What Problem Jitter Solves for Optical Transmitters

(Comments 256, 257, 258, 259)

IEEE 802.3dj Plenary Meeting

November 10, 2025

Jitter Characterization of Test Cases

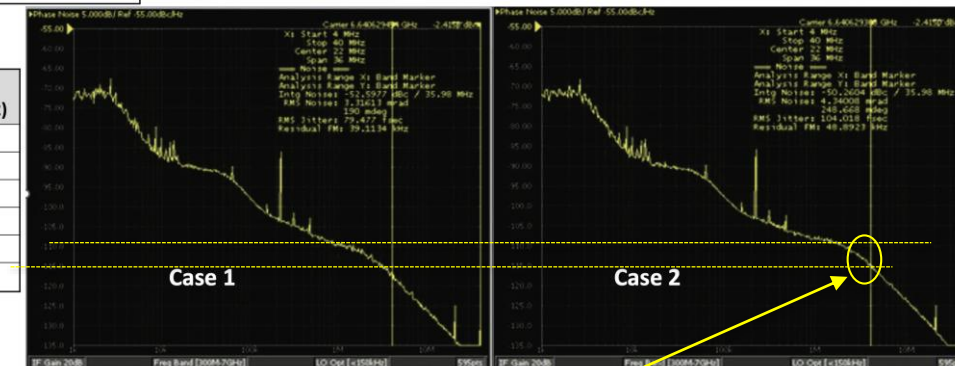
Tiny amount of phase noise increase results in error floor

EECQ/TDECQ Correlation to Input Jitter

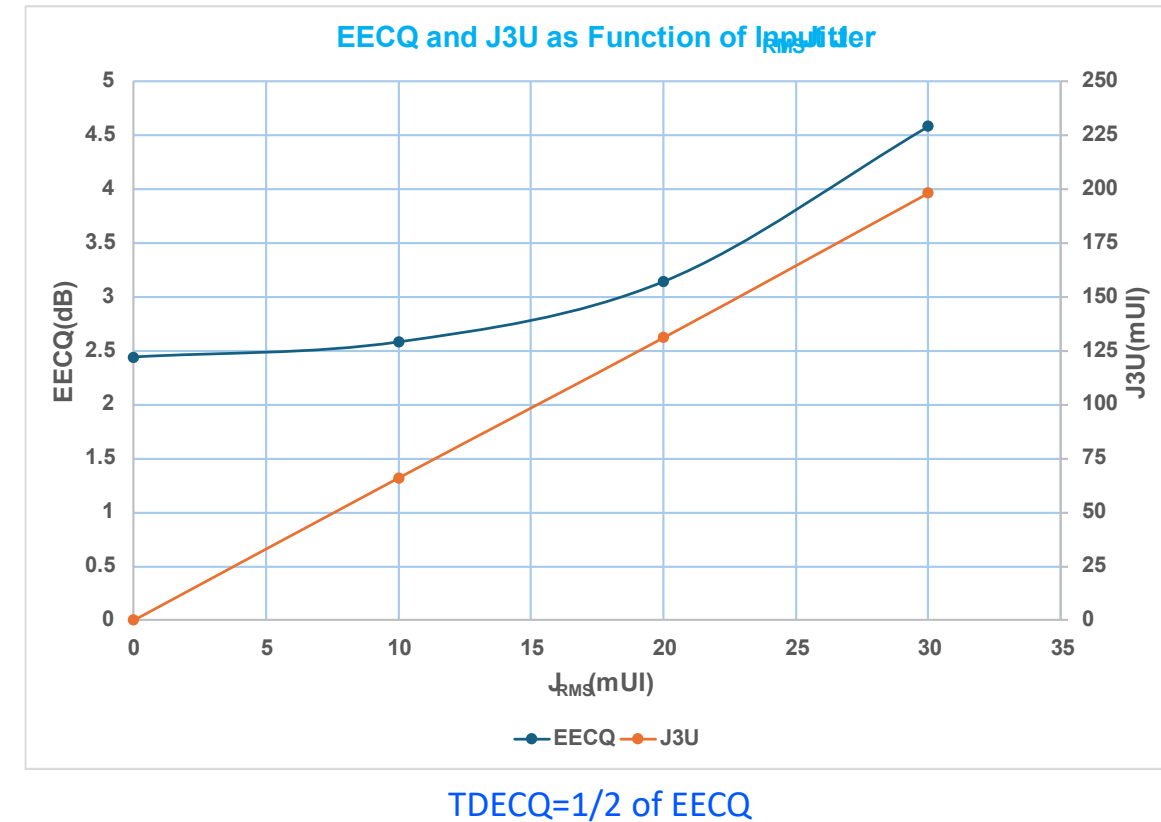
- ❑ For full simulation results, see [ghiasi_3dj_01a_2409](#)
- ❑ Simulation show that there is strong correlation between EECQ/TDECQ and J3U as function of input J_{RMS}
 - J3U is a redundant measurement that is less effective than EECQ/TDECQ measured with a more representative SSPRQ pattern
 - For TDECQ > 1.5 dB, TDECQ and J3U have 1-to-1 relationship
- ❑ EECQ/TDECQ are very effective to capture average jitter/noise
 - However neither TDECQ (except CER_TDECQ with Realtime Scope) or J_{RMS}/EOJ/J4u will identify problematic transmitter reported by [Mazzini OIF 2024.449.02](#) !

FEC performance vs. 12 MHz SJ

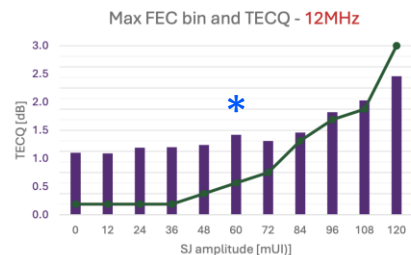
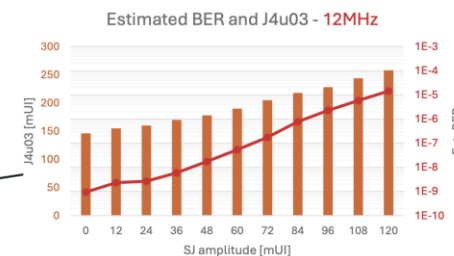
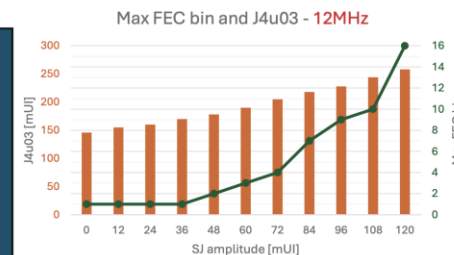
J4u03 is roughly proportional to log(BER);
The highest measured BER is still lower
than the max BER allowed

At the highest SJ, uncorrectable codewords observed within 30 seconds (not predicted by BER≈1e-5; errors are correlated).
J4u03 seems to predict max FEC bin better than TECQ.

FEC performance vs. RJ

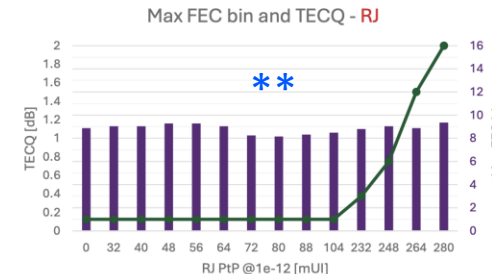
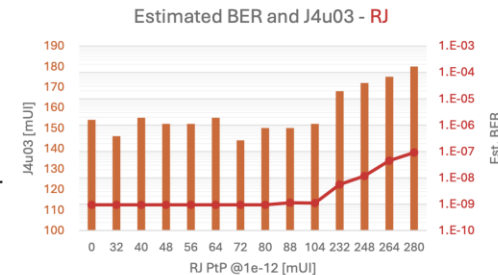
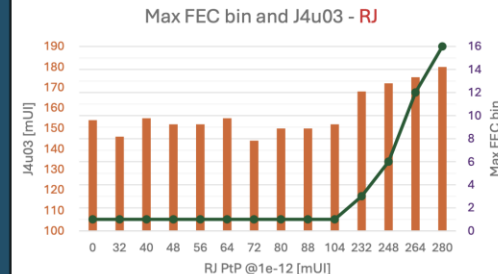
J4u03 is roughly proportional to log(BER).
Low RJ values have no visible effect on BER.

At high RJ levels the FEC performance degrades quickly. uncorrectable codewords observed within 30 seconds (not predicted by BER≈1e-7; errors are correlated).
J4u03 seems to predict max FEC bin better than TECQ.

Functional RX Results

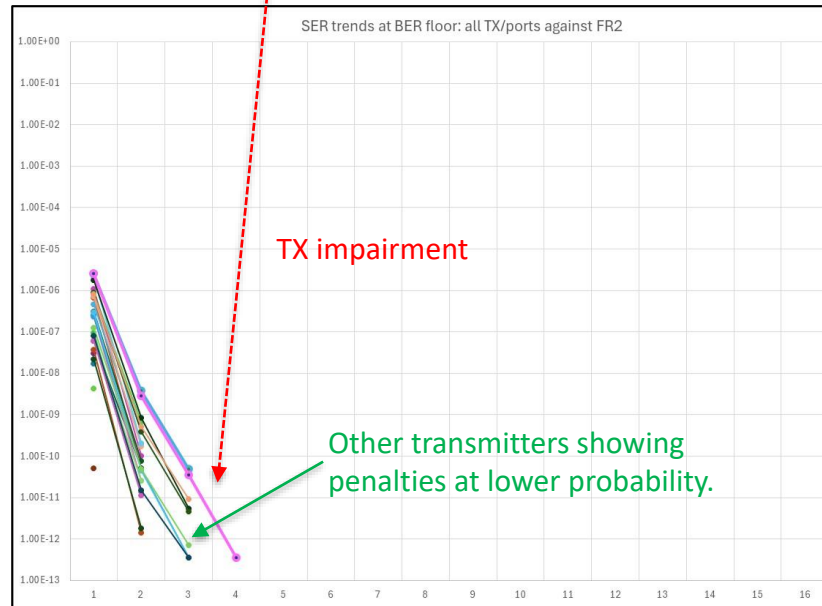
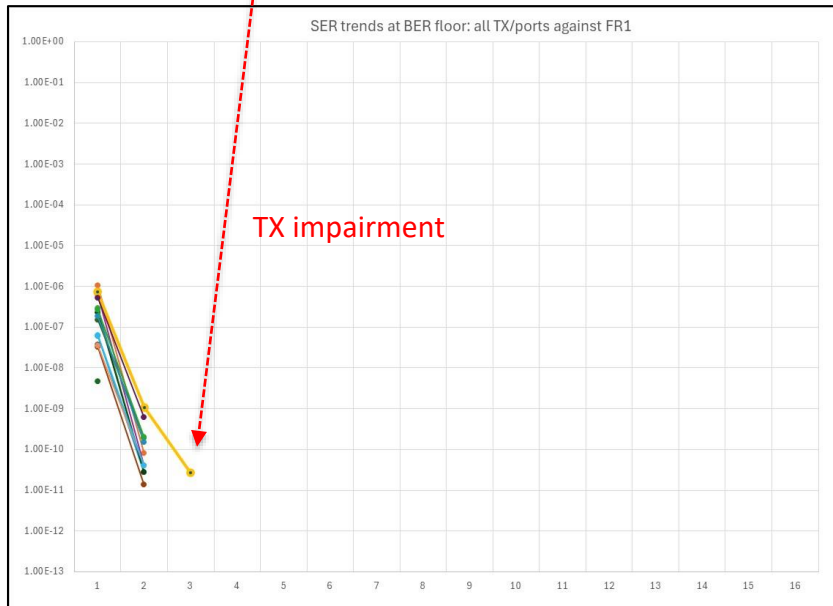
*All transmitters DUT pass the TFSEH mask under this worst-case conditions.
Longer observations are helpful to discriminate lower probability trends.*

Same worst-cases transmitter cases are identified when measuring the ORx at BER floor (input OMA > 0 dBm) on the two functional receivers taken as reference .

In case of BER floor, one can set a dedicated mask (e.g. corresponding to $5E-8$ BER) to further screen parts.
